Subject: Byron Station Units 1 and 2
Braidwood Station Units 1 and 2
Transmittal of Confirmatory Piping
Analysis Information
NRC Docket Nos. 50-454, 50-455, 50-456,
and 50-457

As indicated in Reference (b), some piping supports for the 1FW03DC-16" feedwater line were being redesigned based upon the formal analysis. This redesign effort has been completed and copies of the revised support drawings and analyticals are included with this letter.

PIPING ANALYTICAL & PHYSICAL DATA		FOR FEED WATER SYSTEM	
PROJECT BYRON/BRAIDWOOD-1		SUB SYSTEM NO. IFW04	
CLIENT COMMONWEALTH EDISON CO.		REV. 4	
PROJECT NO. 4391-00 4683-00		SHEET 2 OF 4

SUPPORT NO. M-IFW040043
SHEET 1 OF 1

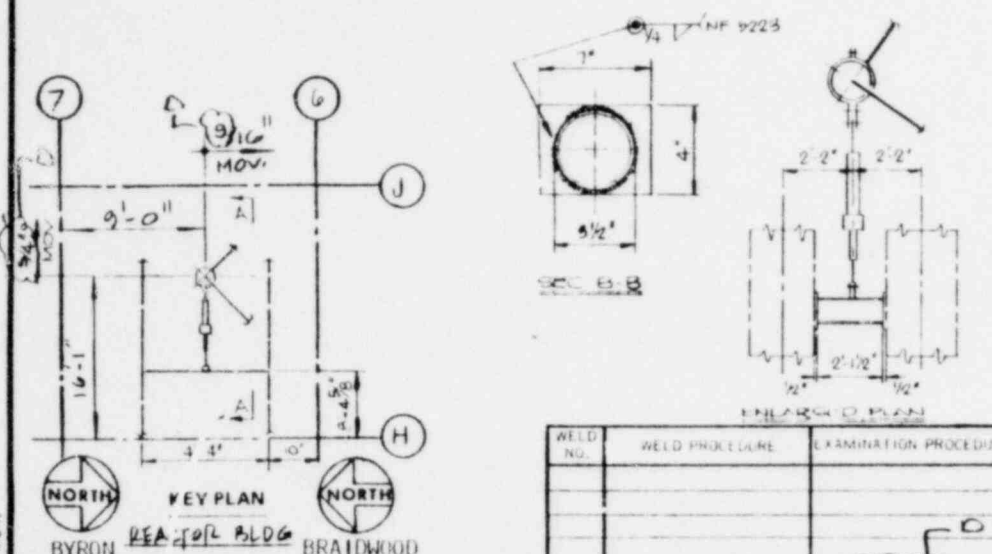
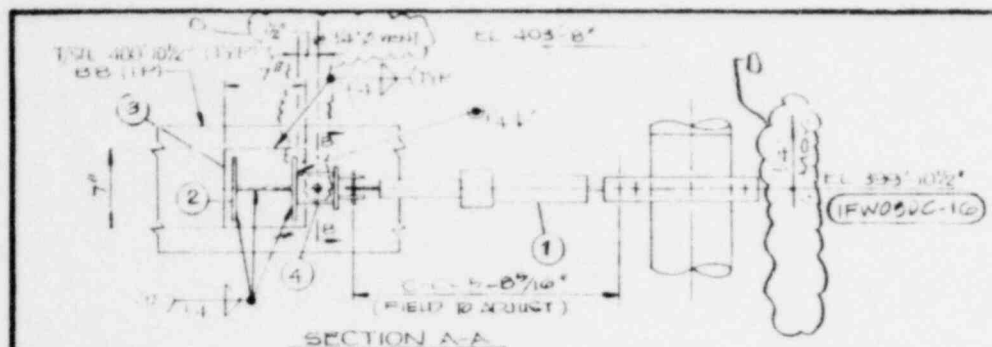
REV.	DESCRIPTION
REV C -	DELETED PER NEW ANALYSIS, LOADS EXCEEDED REPLACED BY IFN040143

SUPPORT NO. M-IFW040055
SHEET 1 OF 1

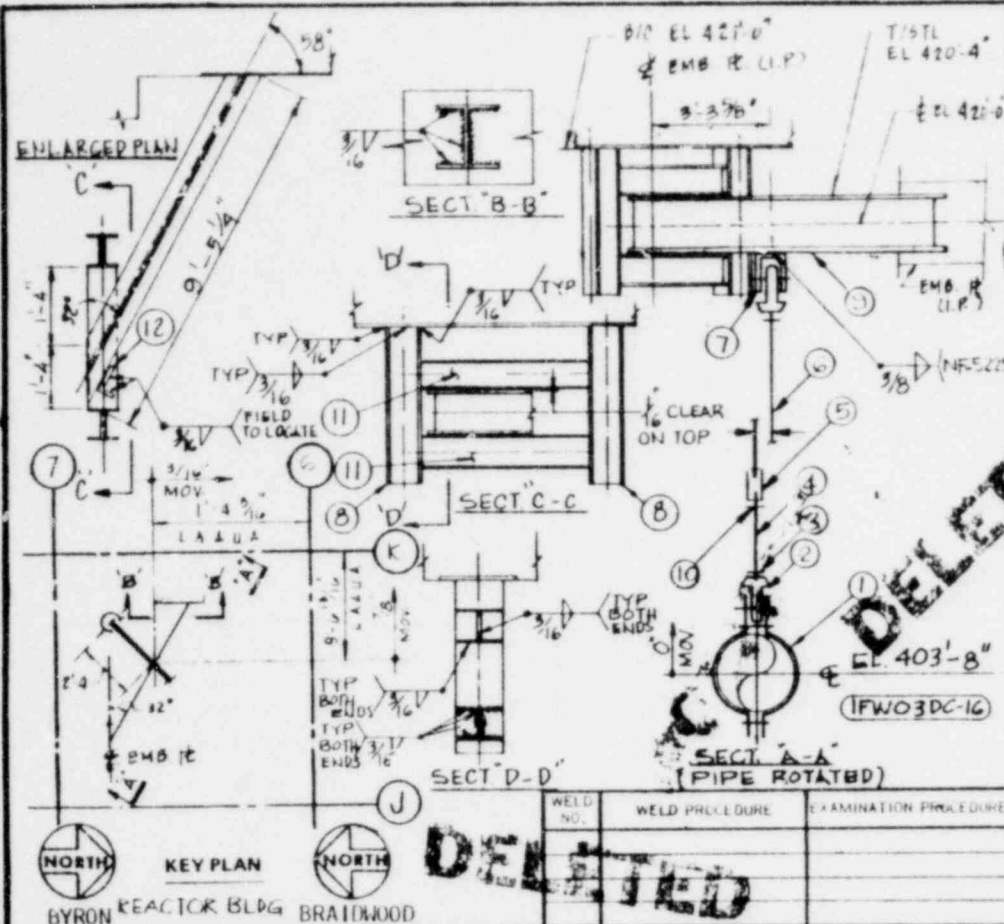
REFERENCE DRAWINGS	DWG. NO.	REV.	DWG. NO.	REV.	DWG. NO.	REV.	DWG. NO.	REV.
	11-163		11-910		11-3773		11-1255	
DRAWING RELEASE RECORD								
REV.	SPEC. NO.	DATE	DRAWN	CHECKED	ENG. R. APPL.	FILM	END. REV. SW	
A		11/3/76	W. J. Johnson	W. J. Johnson	W. J. Johnson			
B		2-14-78	W. J. Johnson	W. J. Johnson	W. J. Johnson			
C		12-22-78	W. J. Johnson	W. J. Johnson	W. J. Johnson			
D		5-5-80	W. J. Johnson	W. J. Johnson	W. J. Johnson			
REVISION DESCRIPTION								
F/L 2771 SUPPLY UNAPPEARED, F/L 2739 FOR CONSTR. REVISION DUE TO NEW STRESS REPORT

SUPPORT NO.	RE
-------------	----

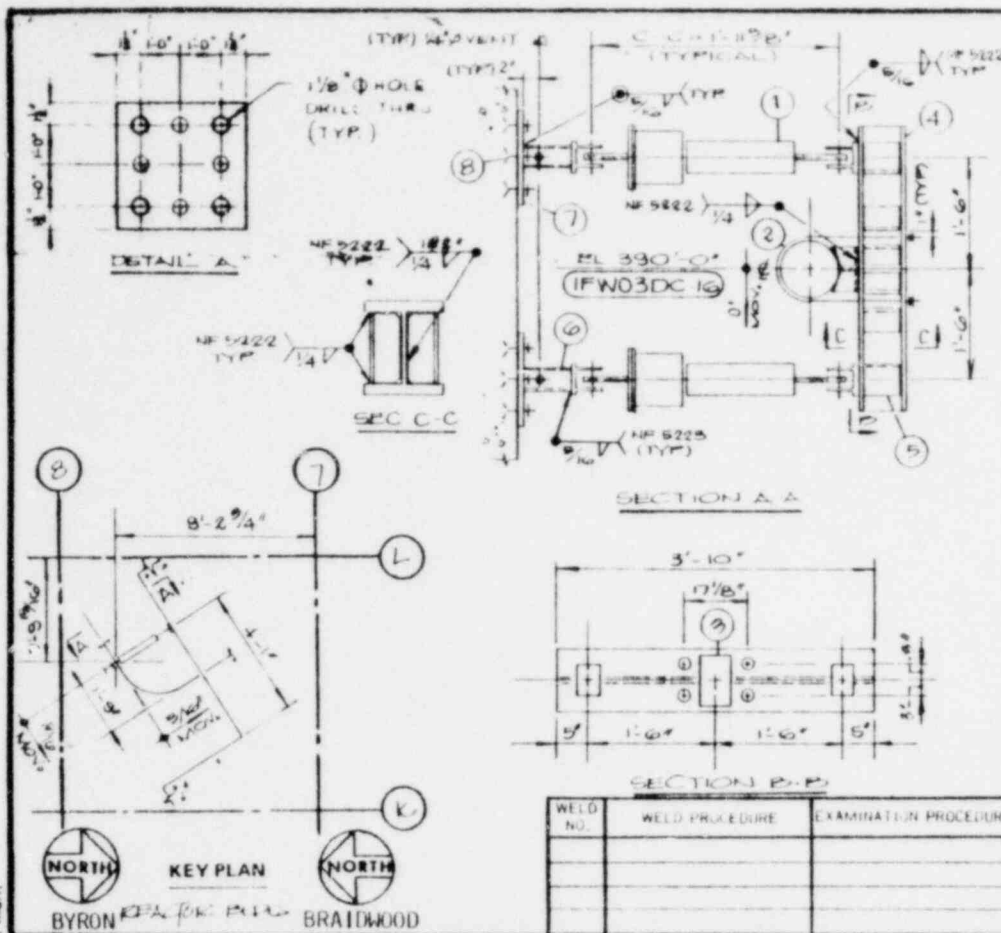
REVISION DESCRIPTION	
REV. D -	DELETED PER NEW ANALYSIS, NO REPLACEMENT

SUPPORT NO. M-IFW04016R
REV A
SHEET 1 OF 1

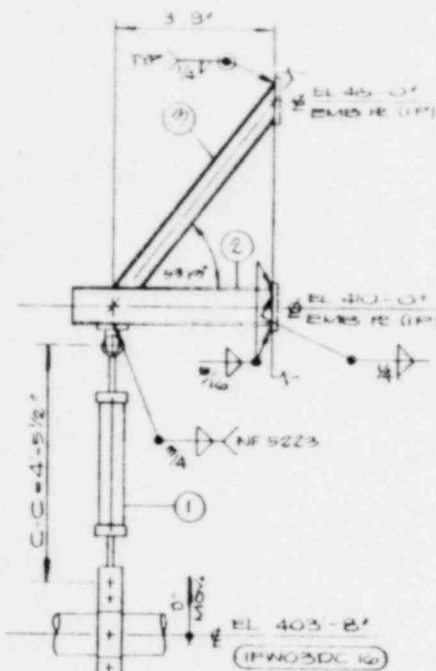
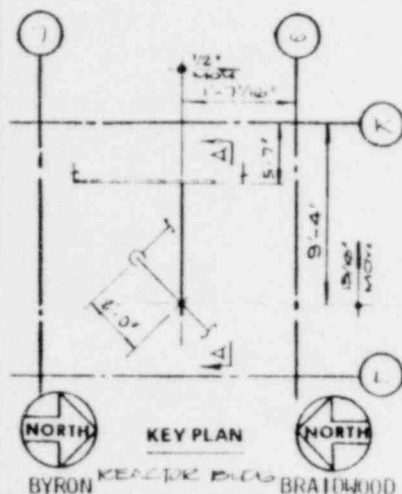
REVISION DESCRIPTION
REPLACES IFW04006R
F/L 2771 FOR FAS, F/L 2733 FOR CONCRE
